### PLANNING COMMISSION AGENDA

**Thursday, June 18, 2020**

3.3. Request: Preliminary Plat approval for Mountain Ridge Phases 1-2, including 94

# Mountain Ridge Engineering DRC Comments June 2, 2020

#### **UFA Comments**

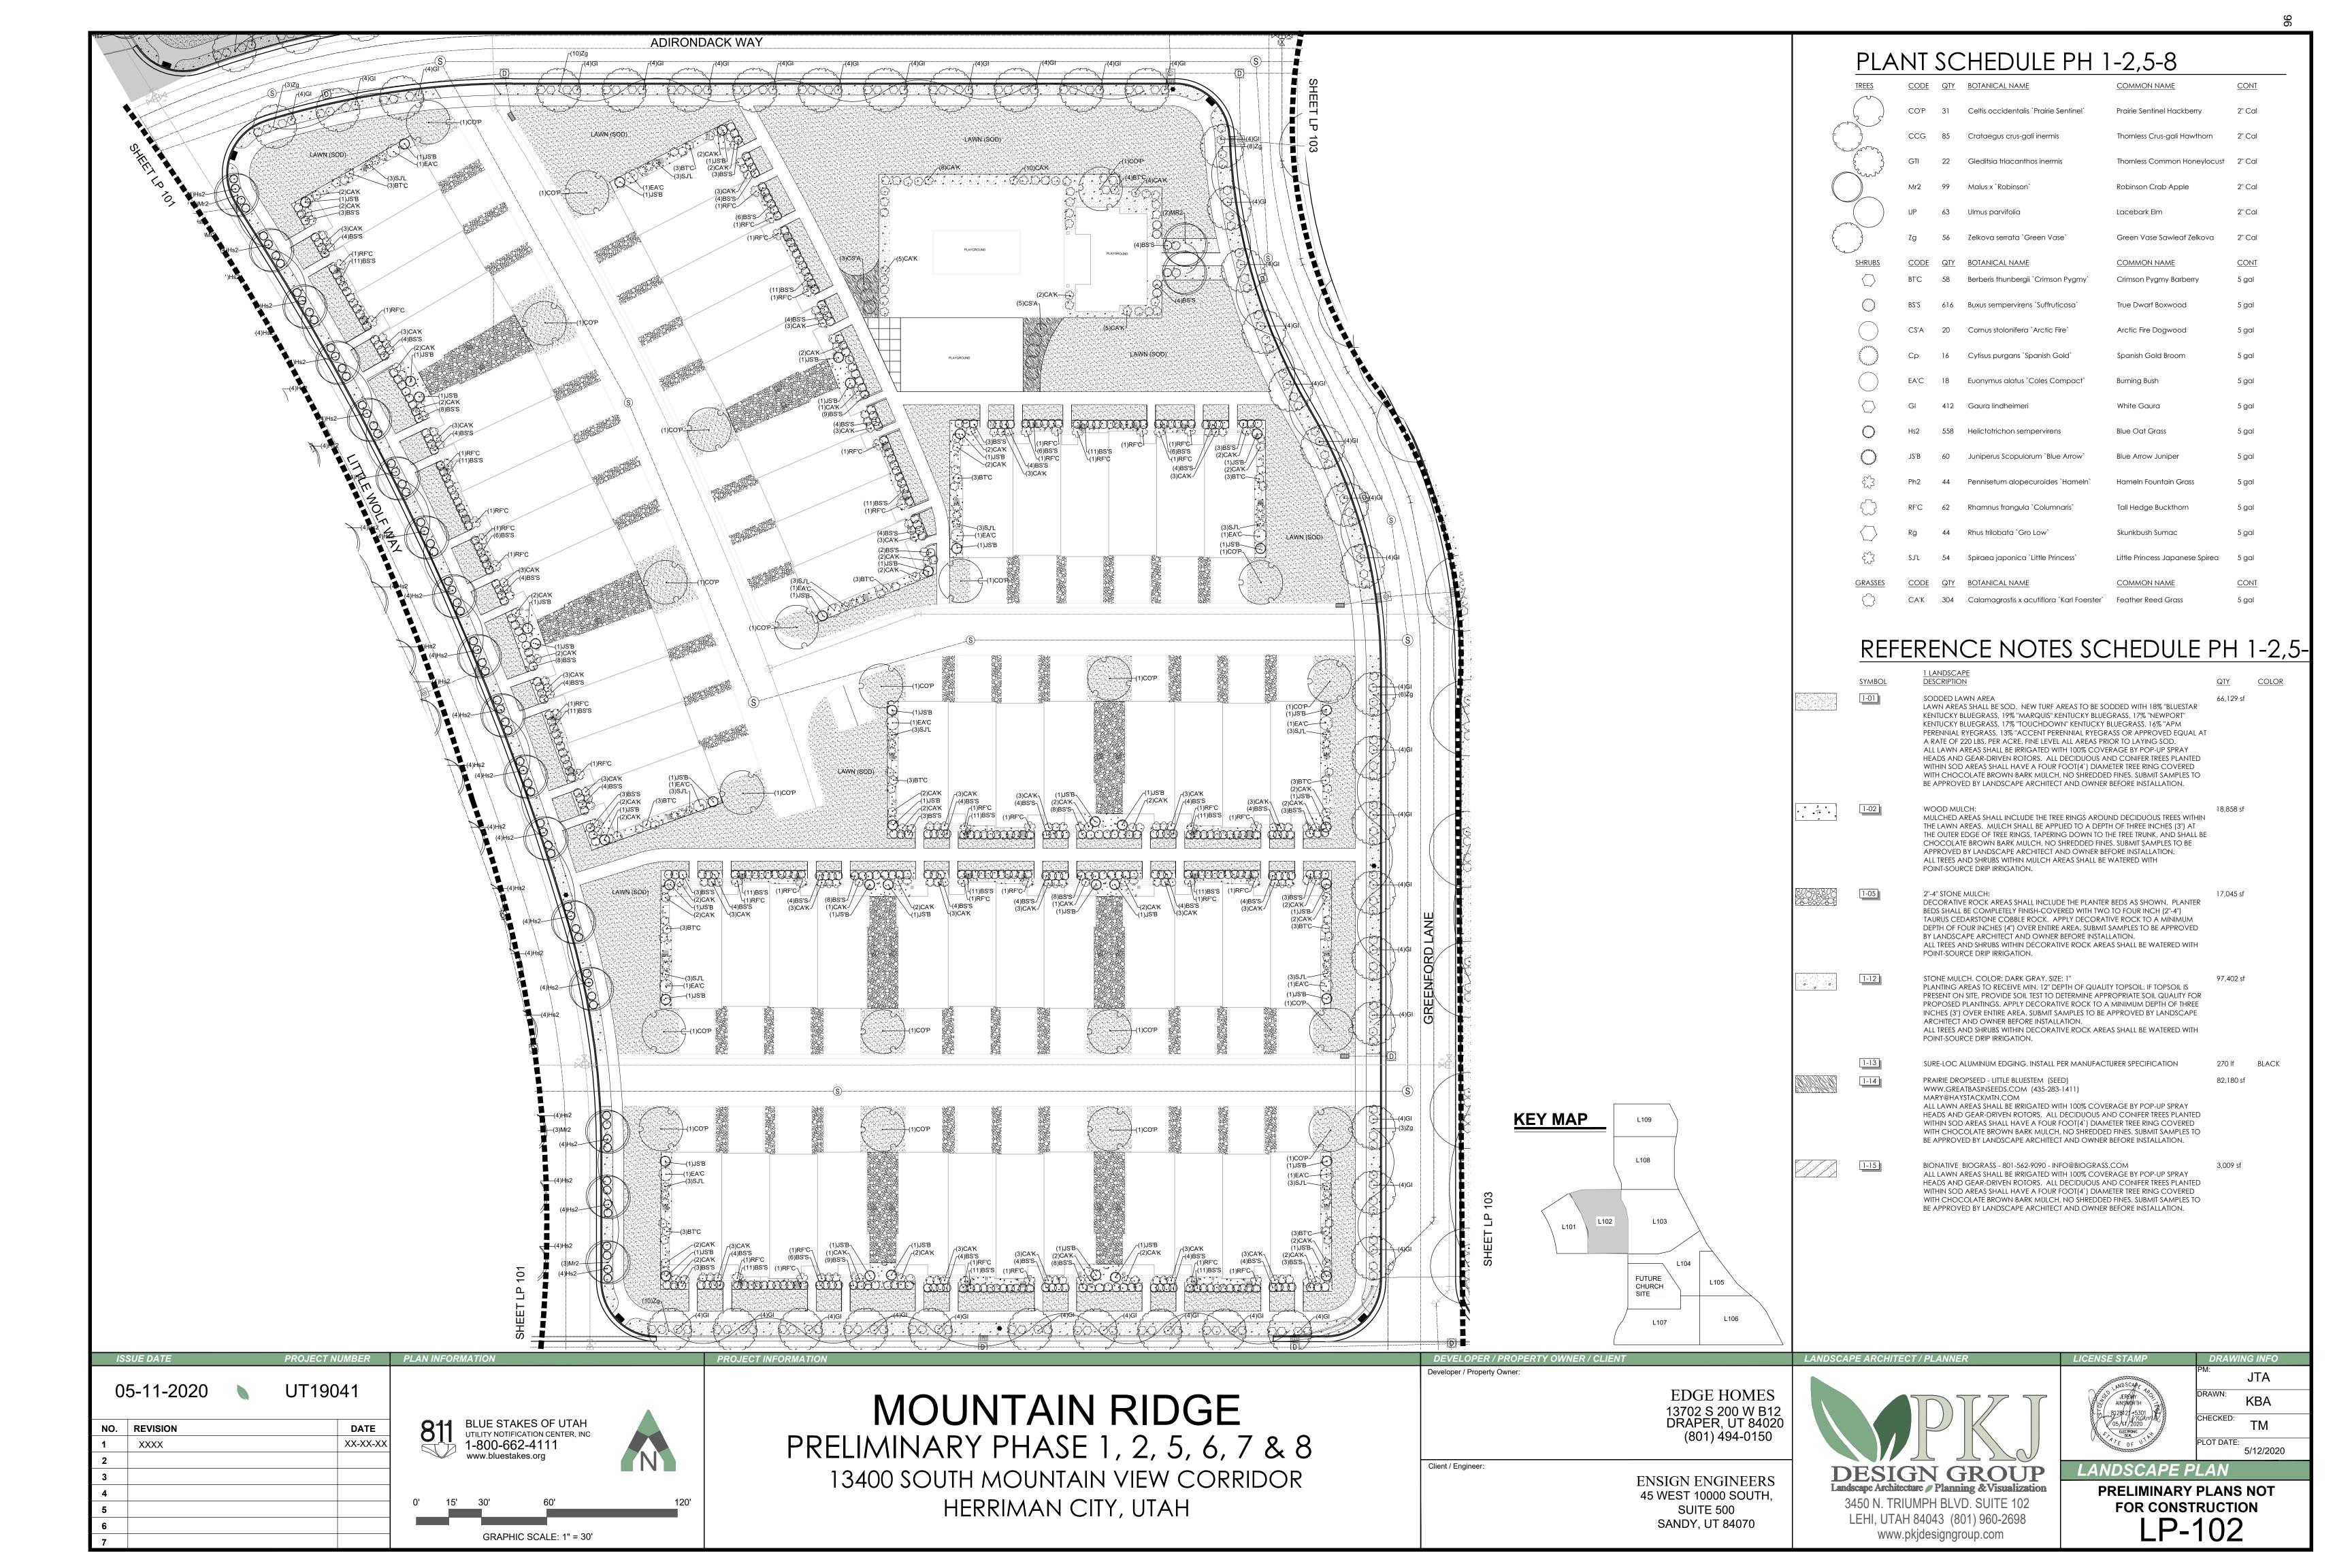
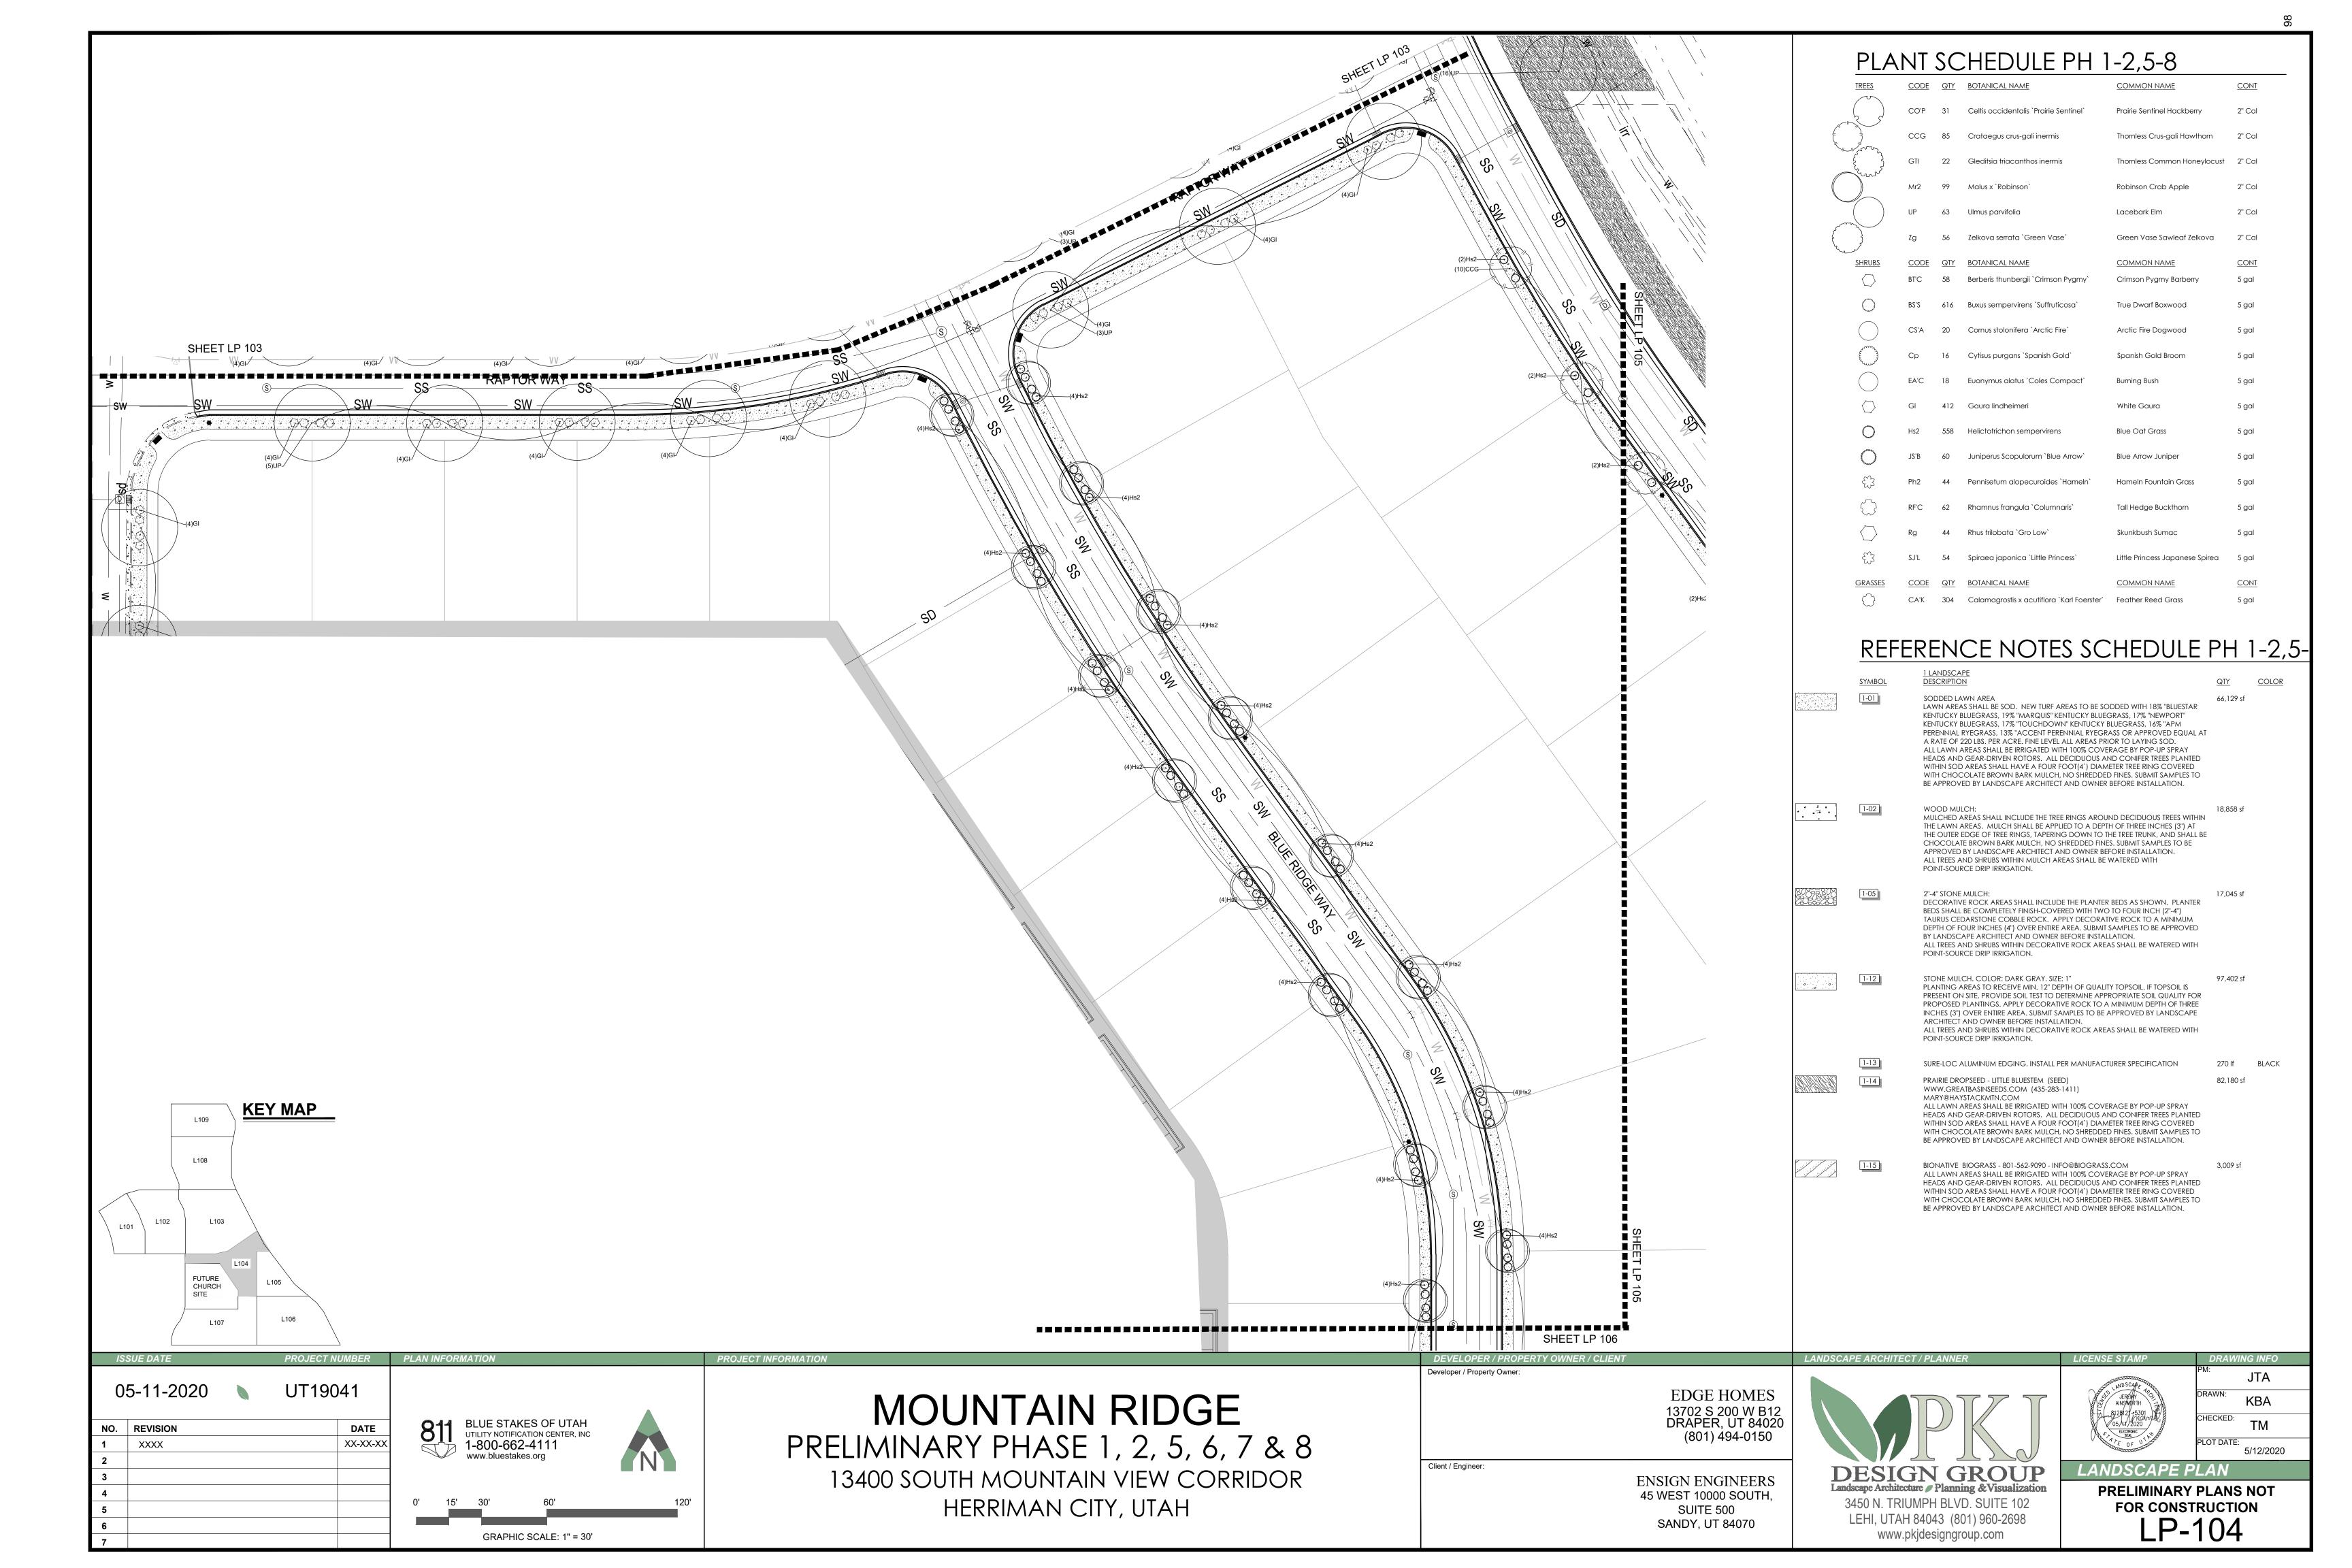
- Show locations of fire hydrants on utility plans.
- Temporary turnaround may be required between phase 7 and 8 depending on timing.
- Private drives and alleys will need to be signed no parking on both sides due to width.
  - o Entrances and 150' intervals.
- Provide road cross sections details.

- Improvements to all public streets to include sidewalk, curb and gutter, landscaped parkstrips to city standards, and city standard lighting.
- Show all road cross sections.

- Include civil details including road improvements, trails, etc.
- Project will need a development drainage master plan for the entire development for review.

- Will ditch be piped in future.
- How will 10 acre park be developed in multi phased approach for detention.
- Include nuisance by-pass piping to prevent muddy bottom in 10 acre park.

- NOI required.
